**SUBDIVISION &  
SIDEWALK WAIVER STAFF REPORT**

**Date: March 9, 2017**

Tillman’s Corner South Subdivision

**CROSS SECTION OF ROW**  
**SCALE: 1" = 20' H.**  
**1" = 4' V.**

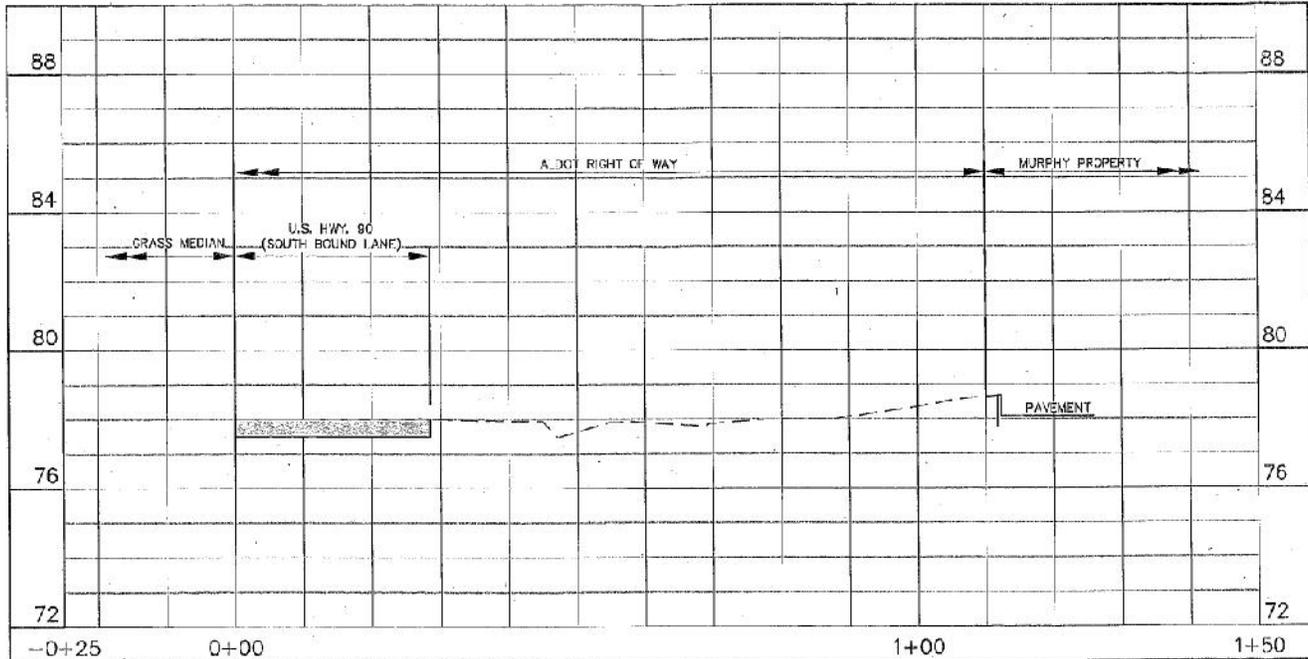
**Sidewalk Waiver:** It appears that there is sufficient room within the ROW for the construction of a sidewalk that could be approved through the City’s ROW Permit process.

In regards to the Sidewalk Waiver, the applicant states “ALDOT in meeting on November 14, 2016 stated that there does not appear to be any need for a sidewalk as there are no other sidewalks near this site and has no objection to the City waiver.” The applicant did submit an

email from ALDOT stating that ALDOT is not requiring sidewalks for this site, but does not state that a sidewalk cannot be built.

The site is surrounded entirely by B-3, Community Business District developed as various offices, retail, and restaurants. While there are no existing sidewalks in the area, other sites will be required to install them as they are redeveloped like the subject site. Furthermore, the applicant is proposing a sidewalk along Halls Mill Road, indicating that a lack of connectivity to existing sidewalks may not be a valid concern.

**Sidewalk Waiver:** Based upon the preceding, the application to waive construction along U.S. Highway 90 West is recommended Denial.
